Access Compliance Report

Public Rights-of-Way

(Curb Ramps)

Intersection ID: 27397	Main Street: ELM_LN	Cross Street: BALLANTYNE_COMMONS_PY	Location: NE
ADA ID: 7C549BC92A1E	Ramp Type: Perp	Initial Pass/Fail: Fail	Overall Compliance: No
		Severity Score: 22.5

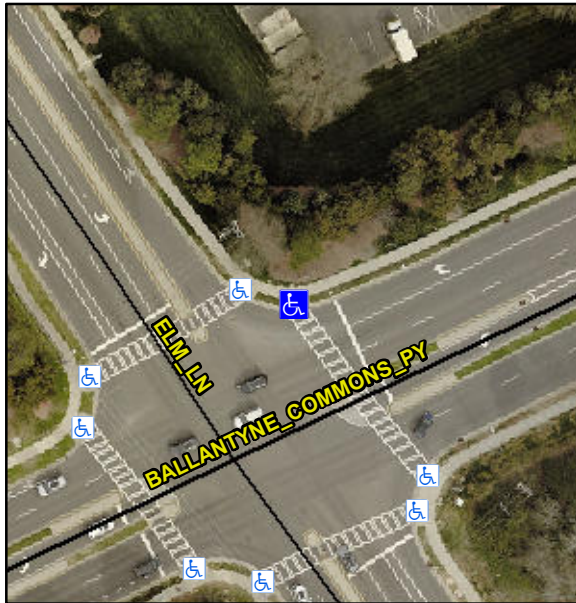
Not Found, R304.5.1, R304.2.2, R304.5.3

Compliance	Description	Data	Compliance	Description	Data
N/A	Ramp Length (in)	47.0	No	Ramp Slope (%)	8.7
No	Ramp Width (in)	46.5	No	Ramp XSlope (%)	4.7
N/A	Flare Type LT	N/A	N/A	Flare Type RT	N/A
N/A	Flare Slope LT (%)	N/A	N/A	Flare Slope RT (%)	N/A
N/A	Flare Traversable LT?	N/A	N/A	Flare Traversable RT?	N/A
N/A	Landing Length (in)	N/A	N/A	DWS Provided?	N/A
N/A	Landing Width (in)	N/A	N/A	DWS Contrast?	N/A
N/A	Landing Slope (%)	N/A	N/A	DWS Length (in)	N/A
N/A	Landing X Slope (%)	N/A	N/A	DWS Full Width?	N/A
N/A	Landing Curb? (Y/N)	N/A	N/A	DWS Offset (in)	N/A
N/A	Shared Landing?	N/A			
N/A	Gutter Ponding?	N/A	N/A	Gutter Slope (%)	N/A
N/A	Gutter Lip Ht (in)	N/A	N/A	Gutter X Slope (%)	N/A
N/A	Painted X Walk1?	Yes	N/A	Painted X Walk2?	N/A
	X Walk 1 Direction	To SE		X Walk 2 Direction	N/A
N/A	X Walk 1 Width (in)	112.0	N/A	X Walk 2 Width (in)	N/A
	X Walk 1 Slope (%)	0.8		X Walk 2 Slope (%)	N/A
	X Walk 1 X Slope (%)	2.4		X Walk 2 X Slope (%)	N/A

Remove & Replace Entire Ramp.
